SB, X-halt, belt and pulleys, K7000, 2024-05

Figure 4: IPL position.

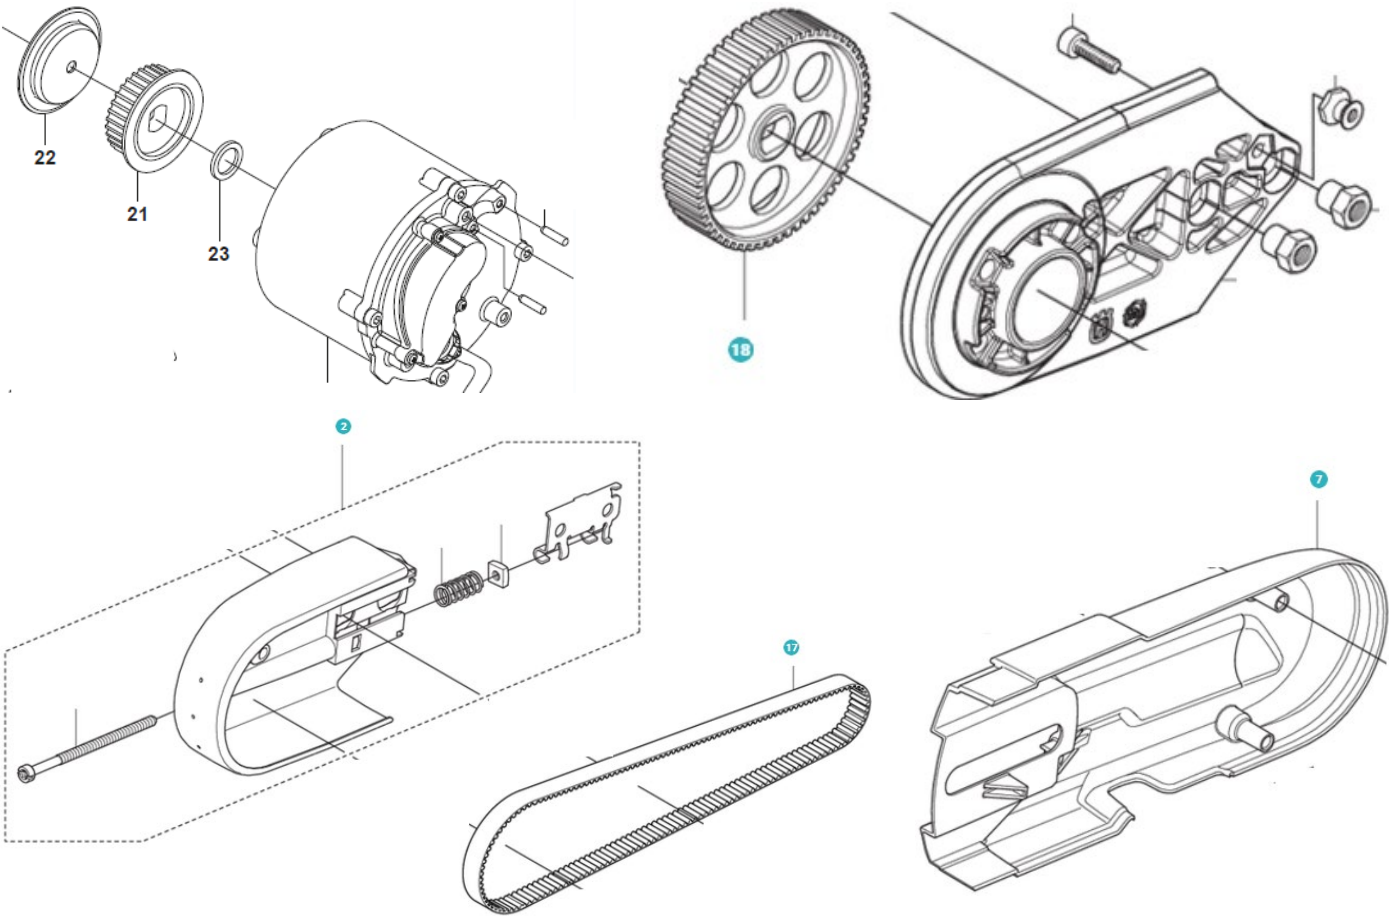
Part name	Old part no.	New part no.	IPL Position **
Upgrade kit X-halt	<i>New part no.</i>	547246401	
Belt *	<i>New part no.</i>	546126901	17
Forward pulley *	<i>New part no.</i>	546053601	18
Rear pulley *	<i>New part no.</i>	547028401	21
Rear belt guard *	525341301	525341303	7
Front belt guard *	506393602	506393604	2
Flange *	<i>New part no.</i>	546080601	22
Washer*	<i>Existing Part</i>	503230104	23
Cutter arm	525339401	525339403
